CHANGE NOTIFICATION

December 19, 2012 PCN#: 121912

Subject: **Notification of Assembly Process change for LTM8022, LTM8023 and LTM8052**

LTM8022- Current and New DESIGN

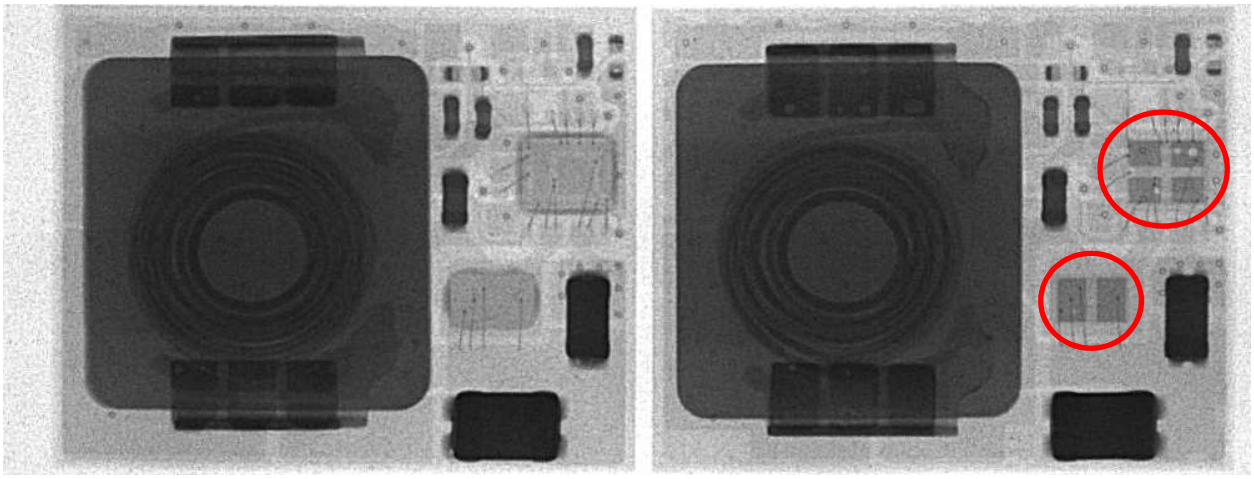
Please be advised that Linear Technology Corporation has made a minor change to the internal package construction to facilitate the use of one attach material for both die and components. The die attach material is changed from epoxy to solder, which is already used for attaching components in the same µModule device package. In order to use the solder die attach, the die paddle (DAP) has been modified by splitting the DAP into multiple pads for dice D1, Q1 and U1. Linear has been shipping several µModule devices using solder for die attach and component attach.
